Access Compliance Report

Public Rights-of-Way

(Curb Ramps)

Intersection ID: 29110	Main Street: EASTFIELD_RD	Cross Street: ARBOR_CREEK_DR	Location: S
ADA ID: CB3D41B83FBA	Ramp Type: Perp	Initial Pass/Fail: Fail	Overall Compliance: No
Severity Score: 13.75			
Codes/Mitigation Info/Possible Solution		Field Measurements/Component Compliance

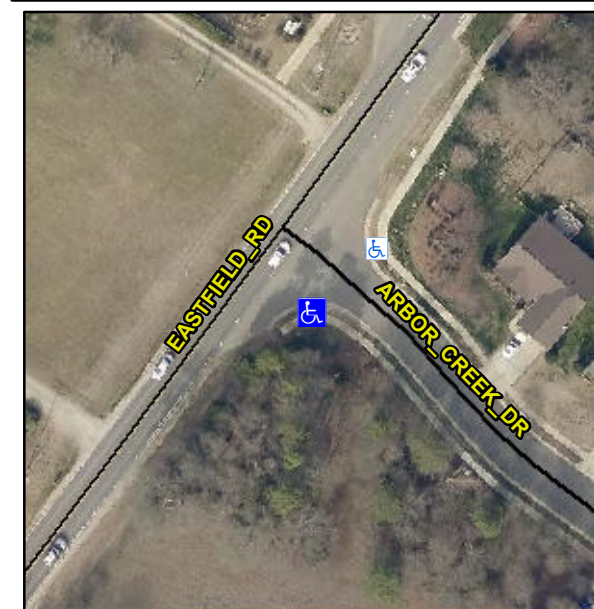
R304.2.2, R304.5.3

Compliance	Description	Data	Compliance	Description	Data
N/A	Ramp Length (in)	48.0	No	Ramp Slope (%)	8.9
Yes	Ramp Width (in)	120.0	No	Ramp XSlope (%)	3.4
N/A	Flare Type LT	N/A	N/A	Flare Type RT	N/A
N/A	Flare Slope LT (%)	N/A	N/A	Flare Slope RT (%)	N/A
N/A	Flare Traversable LT?	N/A	N/A	Flare Traversable RT?	N/A
N/A	Landing Length (in)	N/A	N/A	DWS Provided?	N/A
N/A	Landing Width (in)	N/A	N/A	DWS Contrast?	N/A
N/A	Landing Slope (%)	N/A	N/A	DWS Length (in)	N/A
N/A	Landing X Slope (%)	N/A	N/A	DWS Full Width?	N/A
N/A	Landing Curb? (Y/N)	N/A	N/A	DWS Offset (in)	N/A
N/A	Shared Landing?	N/A			
N/A	Gutter Ponding?	N/A	N/A	Gutter Slope (%)	N/A
N/A	Gutter Lip Ht (in)	N/A	N/A	Gutter X Slope (%)	N/A
N/A	Painted X Walk1?	No	N/A	Painted X Walk2?	N/A
	X Walk 1 Direction	To NE		X Walk 2 Direction	N/A
N/A	X Walk 1 Width (in)	N/A	N/A	X Walk 2 Width (in)	N/A
	X Walk 1 Slope (%)	2.6		X Walk 2 Slope (%)	N/A
	X Walk 1 X Slope (%)	7.6		X Walk 2 X Slope (%)	N/A

Remove & Replace Entire Ramp.
